# Access Compliance Report

## Public Rights-of-Way

### (Curb Ramps)

Intersection ID: 29721	Main Street: COLE_MILL_RD	Cross Street: LANNIER_FALLS_LN	Location: NW
ADA ID: 4483DEA46F8D	Ramp Type: PerpDiag	Initial Pass/Fail: Fail	Overall Compliance: No
			Severity Score: 13.75

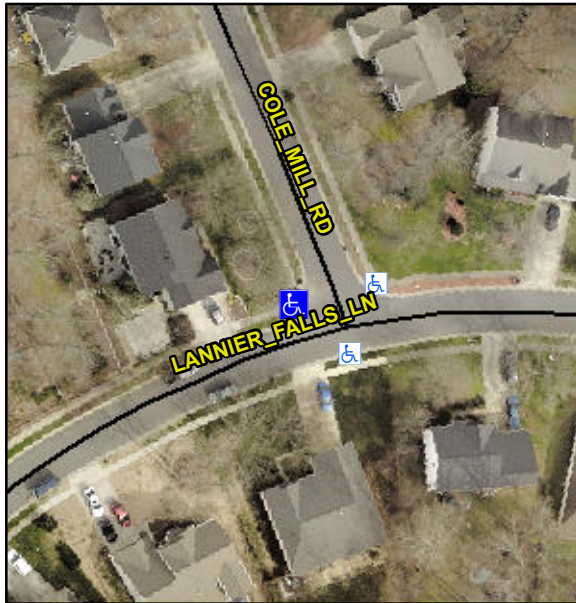
**R304.2.2, R304.5.3**

Compliance	Description	Data	Compliance	Description	Data
N/A	Ramp Length (in)	49.0	No	Ramp Slope (%)	9.1
Yes	Ramp Width (in)	48.0	No	Ramp XSlope (%)	4.0
N/A	Flare Type LT	N/A	N/A	Flare Type RT	N/A
N/A	Flare Slope LT (%)	N/A	N/A	Flare Slope RT (%)	N/A
N/A	Flare Traversable LT?	N/A	N/A	Flare Traversable RT?	N/A
N/A	Landing Length (in)	N/A	N/A	DWS Provided?	N/A
N/A	Landing Width (in)	N/A	N/A	DWS Contrast?	N/A
N/A	Landing Slope (%)	N/A	N/A	DWS Length (in)	N/A
N/A	Landing X Slope (%)	N/A	N/A	DWS Full Width?	N/A
N/A	Landing Curb? (Y/N)	N/A	N/A	DWS Offset (in)	N/A
N/A	Shared Landing?	N/A			
N/A	Gutter Ponding?	N/A	N/A	Gutter Slope (%)	N/A
N/A	Gutter Lip Ht (in)	N/A	N/A	Gutter X Slope (%)	N/A
N/A	Painted X Walk1?	No	N/A	Painted X Walk2?	No
	X Walk 1 Direction	To S		X Walk 2 Direction	To E
N/A	X Walk 1 Width (in)	N/A	N/A	X Walk 2 Width (in)	N/A
	X Walk 1 Slope (%)	3.7		X Walk 2 Slope (%)	1.0
	X Walk 1 X Slope (%)	3.0		X Walk 2 X Slope (%)	0.5

**Remove & Replace Curb Ramp With Two New Directional Ramps or Equivalent.**
